35/13-980P 3 Chevy Chase Circle

All Saints Church (Chevy Chase Vil.HD)

**Address:** 3 Chevy Chase Circle **Meeting Date:** 08/12/98  
**Resource:** Chevy Chase Village Historic District **Review:** HAWP  
**Case Number:** 35/13-98P **Tax Credit:** None  
**Public Notice:** 07/29/98 **Report Date:** 08/05/98  
**Applicant:** All Saints' Church,  
John L. Samperton, AIA **Staff:** Perry Kephart

**PROPOSAL:** Construct New Addition and Memorial Garden

REVISED APPROVED 1993 PRELIMINARY PLAN AND  
**REVISED SITE PLAN**

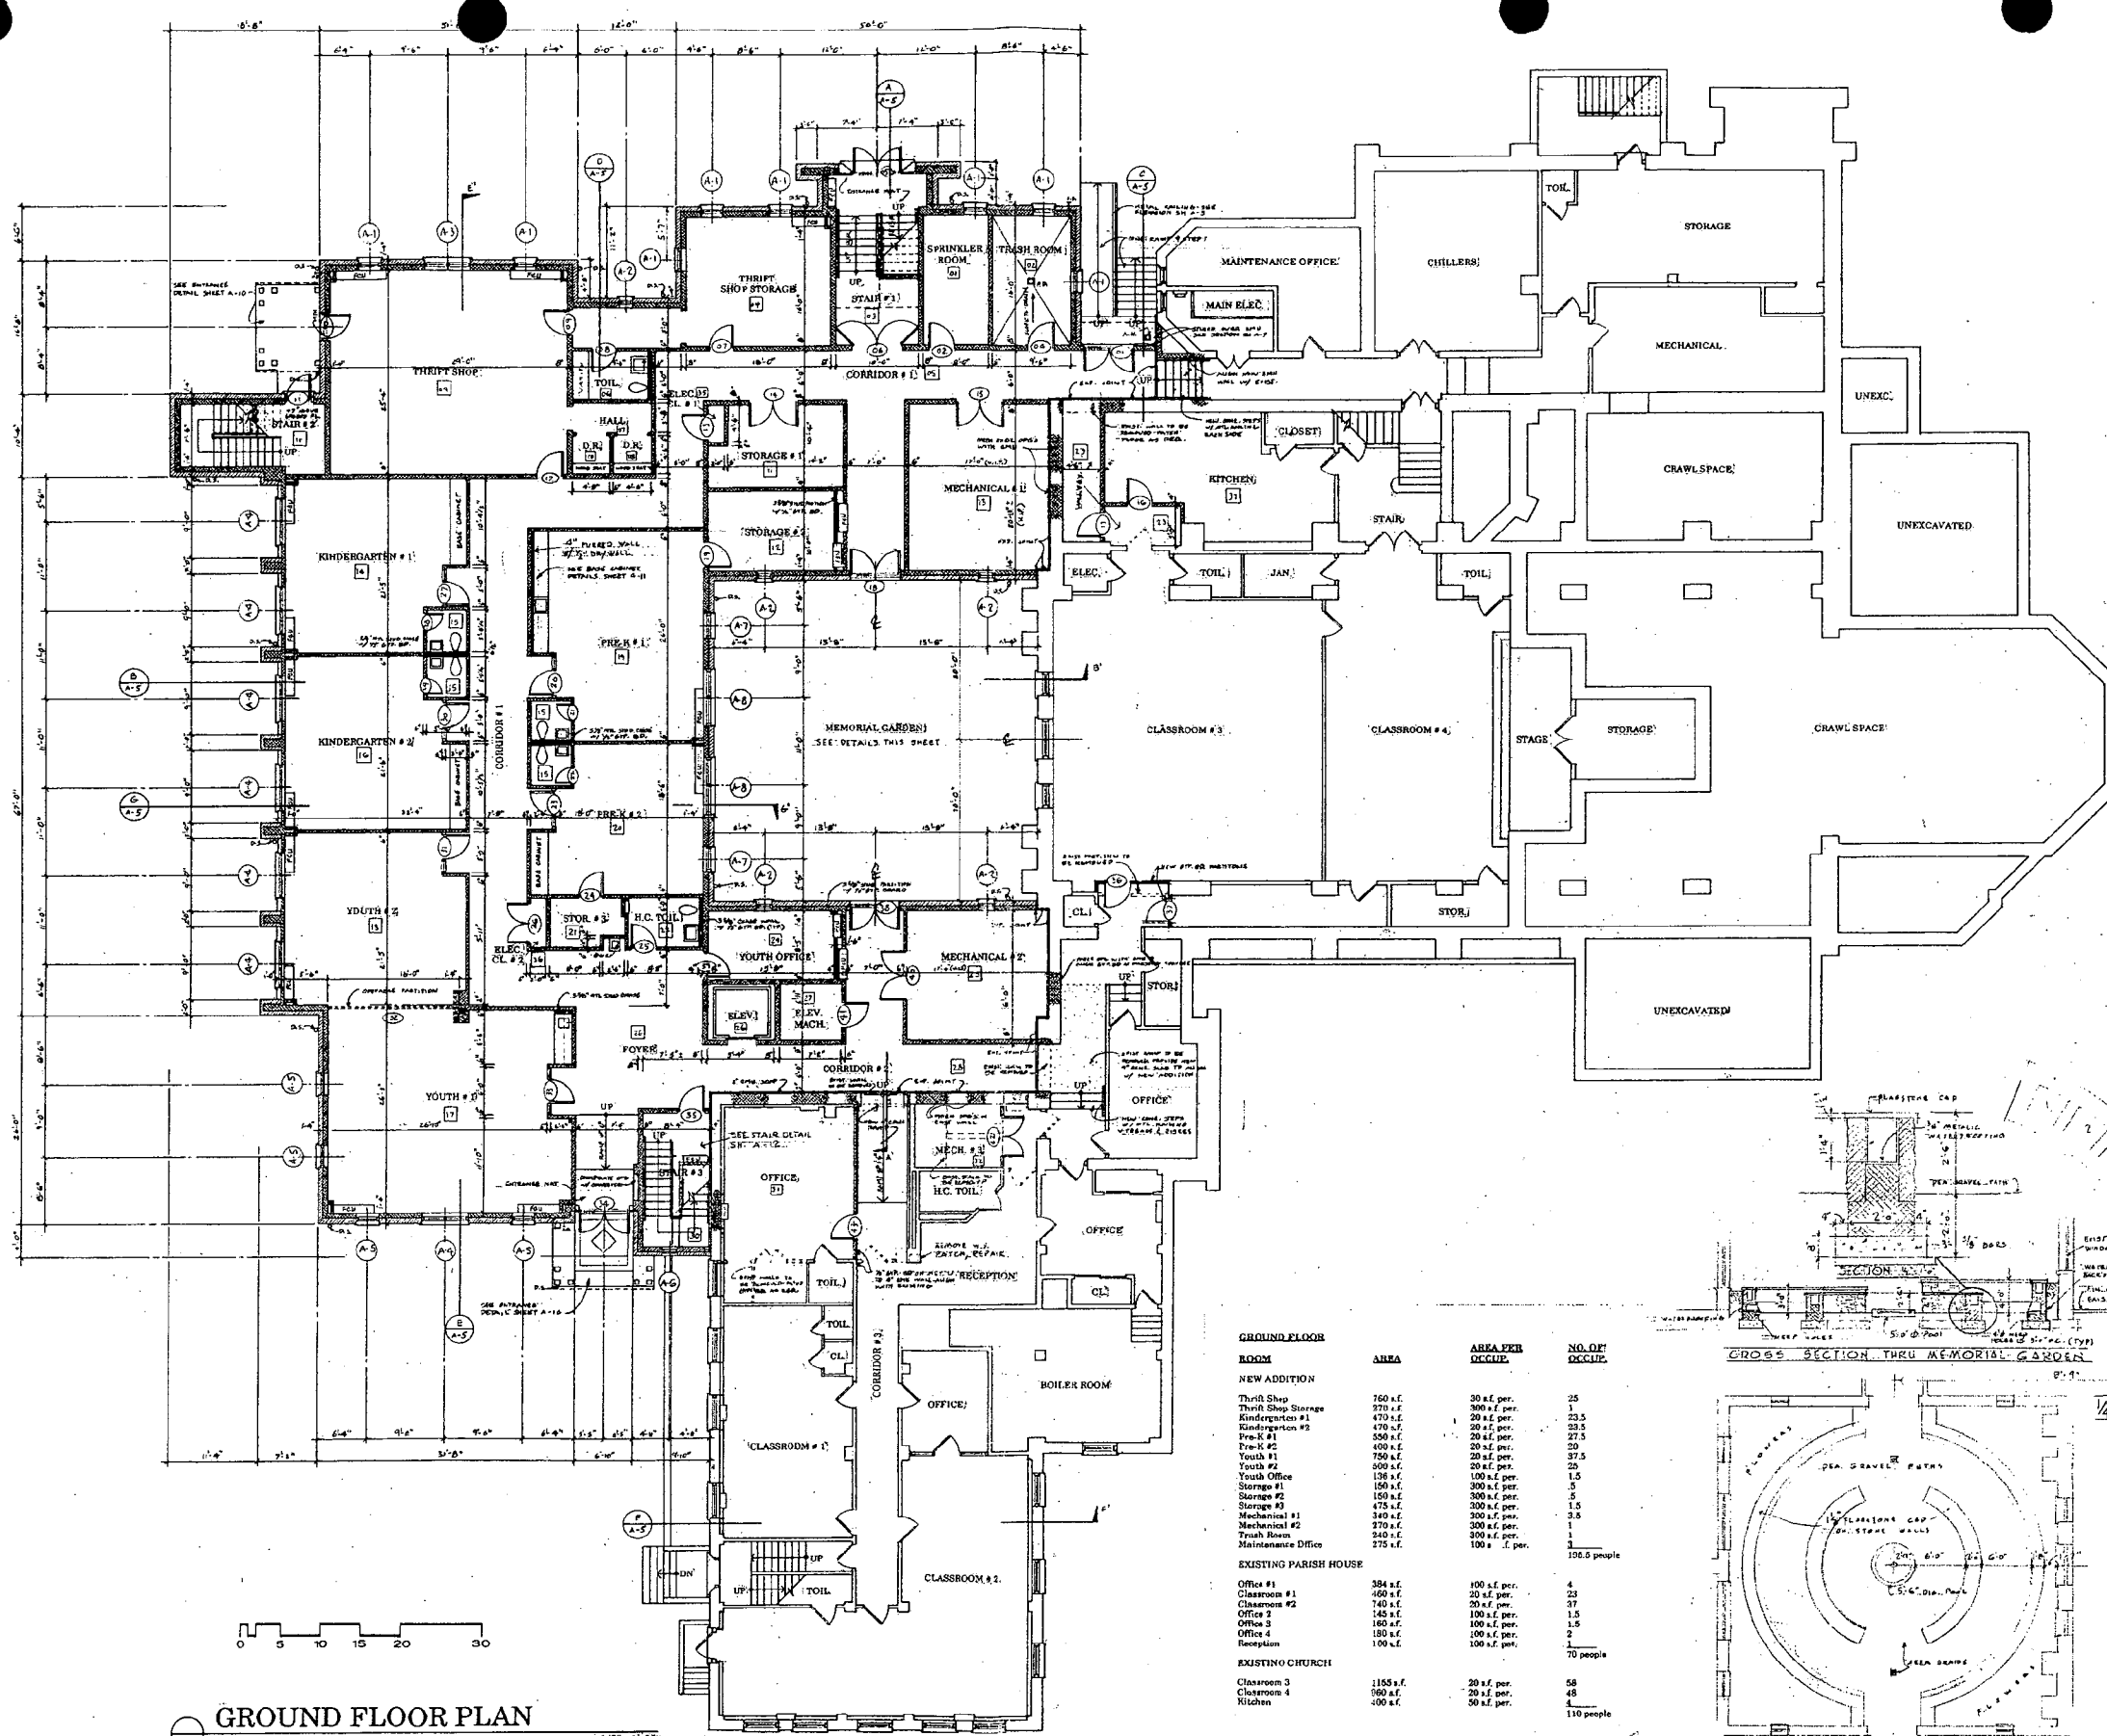
As requested by you, I have listed the following comments on the "Revised Site Plan" by Loiederman Assoc. dated 6/98.

1. General Note 4 - Boundary is by Macris, Hendricks & Witmer on 10/5/89 - the boundary is by Donald Remmer, L.S. of Loiederman Associates. The boundary shown on the Site Plan does not agree with the boundary on the Plat. They should agree.

2. The SWM easement shown on the Record Plat does not cover the revised area of the access roadway shown on the Site Plan. The easement should be revised to cover the roadway.

3. The 10' P.U.E. should be shown.
4. The trash storage area should be shown & how truck access is to be provided.
5. There are several storm drainage pipes entering the underground SWM facility. We need revised plans and computations for the new SWM facility.

6. Note says "prop. oil-grit separator inlet", without a leader to the separator
7. The D/W entrance off Oliver St. should be all new construction.
8. The following areas should be shown on the plan or provided:

- a) paved area (road, walks, etc.)
  - b) new building area (Is the fellowship hall area of 17,722 S.F. as shown in the agreement the same as on the site plan?)

9. Landscaping is not shown - Is a separate plan proposed?
10. 4" SHC clean out is shown in the roadway. Another location out of the roadway would be preferable.
11. Two new SHC are shown incl. one across the rectory lot. An easement for this should be provided. Is the one into Grafton St. unavoidable?
12. Can roof drains that now go to the curb be collected & placed underground?
13. The proposed 10' S.D. easement across the rear of both church lots should be shown
14. What special requirements are necessary by virtue of the church being within the Chevy Chase Historic District?
15. Building setbacks shown on item 12 do not appear to correspond to the BRL lines shown on the site plan. Does the approval of this plan effectively give approval of the existing building being over the BRL?

PLAN OF MEMORIAL GARDEN

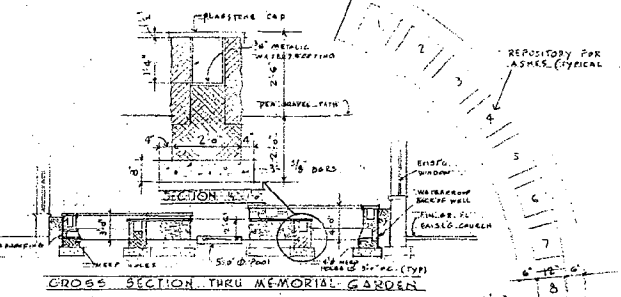
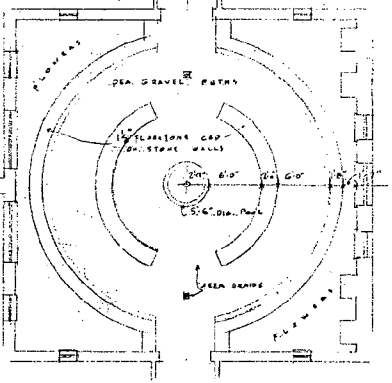
The plans for the memorial garden have not been included in the current proposal. Staff would suggest that they be submitted either for staff approval, or for review by the HPC as a revision to this application.

1. Architectural detailing including the windows and door of the chapel be donated to a preservation organization such as Old House Parts for reuse in the county.
2. Submit the plans for memorial garden to the HPC for review as a revision of this Historic Area Work Permit.
